## June Minutes

Thursday, June 1, 2017; 7:00 p.m.

### HPC-17-37 – 3802 Church Road, Ellicott City, O-907

**HPC-17-38 – 3646 Fels Lane, Ellicott City, HO-979**

Figure 4 - Close up of porch to be repaired

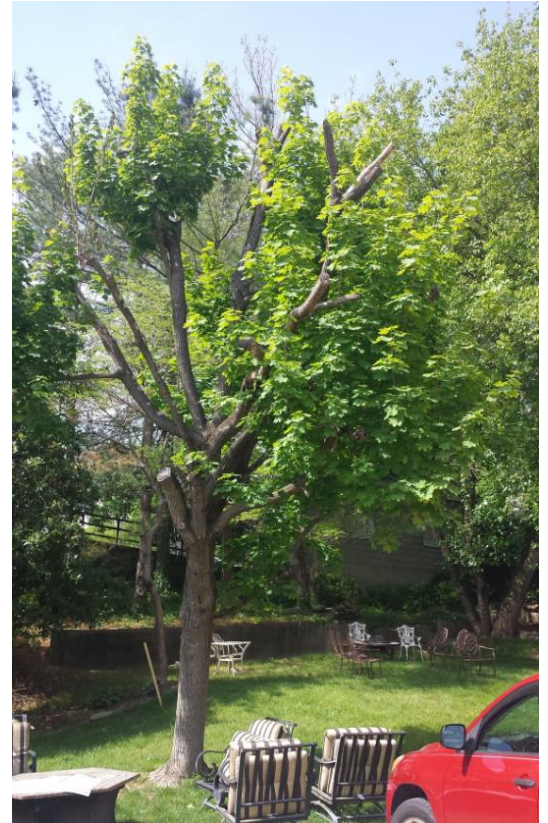
The painting of the porch and replacement of rotten wood floorboards with new wood floorboards is considered Routine Maintenance. This item is eligible for tax credits per Section 20.112 of the County Code. The porch has peeling paint and soft/rotten floorboards as well, that require replacement. The repairs comply with Chapter 6.F recommendations, “maintain and repair porches and balconies, including flooring, ceilings, railings, columns, ornamentation and roofing, that are original or that reflect the building’s historic development” and “replace deteriorated features with new materials as similar as possible to the original in material, design and finish.”

**Staff Recommendation:** Staff recommends Denial of the concrete patio and recommends Approval of a 200 square foot stone patio, in a stone color to match the house. Staff recommends Approval of the gas meter installation and tree removal. Staff recommends Approval and tax credit pre-approval for the porch repairs.

**Figure 8 - Proposed deck and pergola**

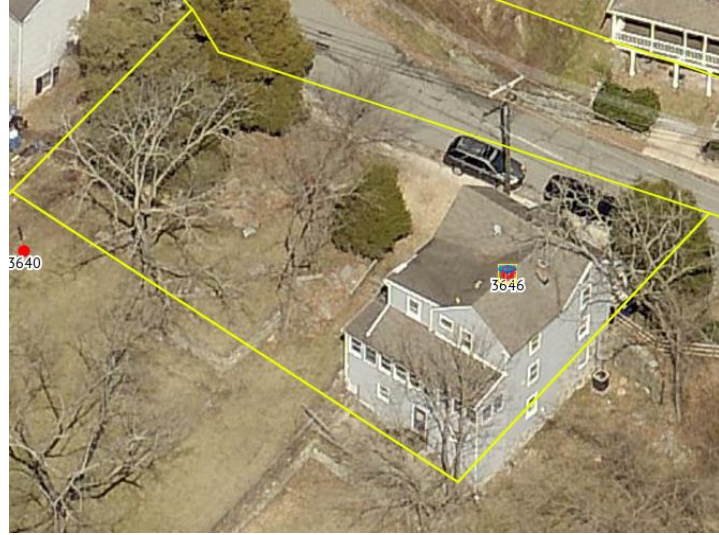
**Staff Comments:** The proposed deck does not comply with the Guidelines. Chapter 7.B of the Guidelines states, “decks should not be added to a historic building’s primary façade or a façade highly visible from a public way...and should be related in detail as much as possible to the style and character of the building.” This chapter states that the Guidelines for building additions are also applicable for new decks. Chapter 7.A explains, “typically, the primary view of a building is its front façade. However, Ellicott City’s hilly topography and winding streets often provide prominent views of a building’s rooftop, side or rear elevations as well as the front façade. When designing an addition, all views of the building should be considered.” The side of the house is highly visible and is the first view of the house as one comes down Fels Lane. Staff finds the proposed deck and pergola are not related to the style and architecture of the house. The proposed location is not appropriate for this proposal and it is not common, if at all found, to see a deck in such a prominent location. It would be more typical to see the porch continued around the side of the house, although on Fels Lane front porches are a highly characteristic building feature.

The proposed deck would start at the top of the granite staircase, visible in Figure 13 below. The deck would extend out over the historic granite staircase and lower portion of the yard. The rendering in Figure 8, above, shows a gap in the railing where a staircase could be located. The Figure 8 rendering does not show a railing coming off the side door, which would be required to avoid a fall hazard down the staircase. However, the rendering in Figure 15, below, does not show the staircase. The Applicant has stated that they would like to construct the staircase, but the contractor was not sure that would be a good location for the stairs. The Applicant would like the option to add the stairs later if determined that it will work. If the Commission approves this project, Staff finds the stairs should come back to the Minor Alterations agenda for approval of the design.

**Staff Recommendation:** Staff recommends the Applicant withdraw the current application and submit a new proposal for a stone patio or a lower deck that is in keeping with the Ellicott City Design Guidelines. Otherwise, Staff recommends Denial of the application as submitted, in which case the Applicant cannot return for one year for the same or similar design.

Figure 15 - Side view of deck and pergola

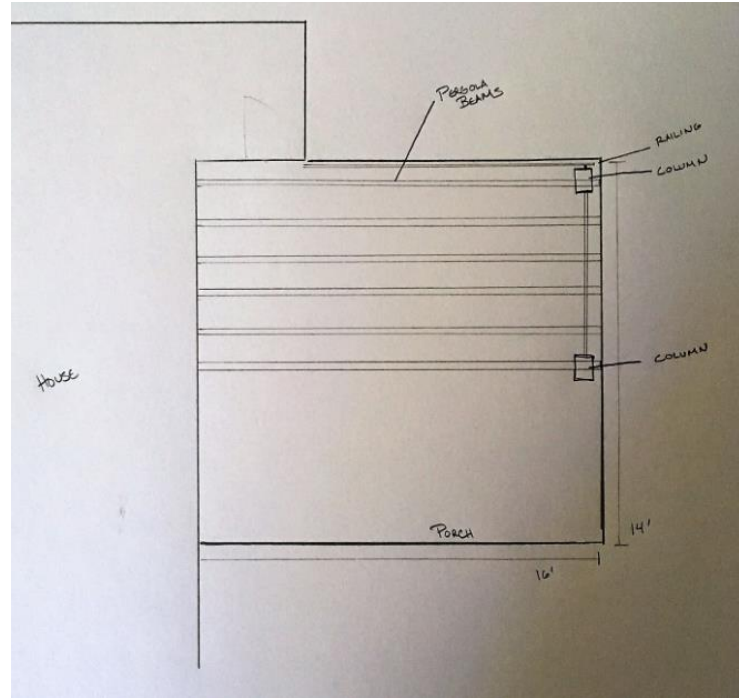
The proposed white railings and columns that would match those on the historic porch do comply with the Guidelines. However, the proposed pressure treated lumber deck does not comply with the Guidelines. Chapter 7.C recommends, “on historic buildings, construct porches of painted wood rather than poured concrete, metal or unpainted wood. Use stained or unpainted wood only for less visible features of a new porch, such as the decking or step treads on the rear of a building in a location not facing or highly visible from a public way.” The proposed deck will be highly visible from the public right

of way and pressure treated lumber is not appropriate. Moreover, painting the proposed deck to simply comply with the Guideline is not appropriate either because it will still read as a deck tacked on to a prominent side of the house, rather than a carefully designed, historically and architecturally compatible addition.
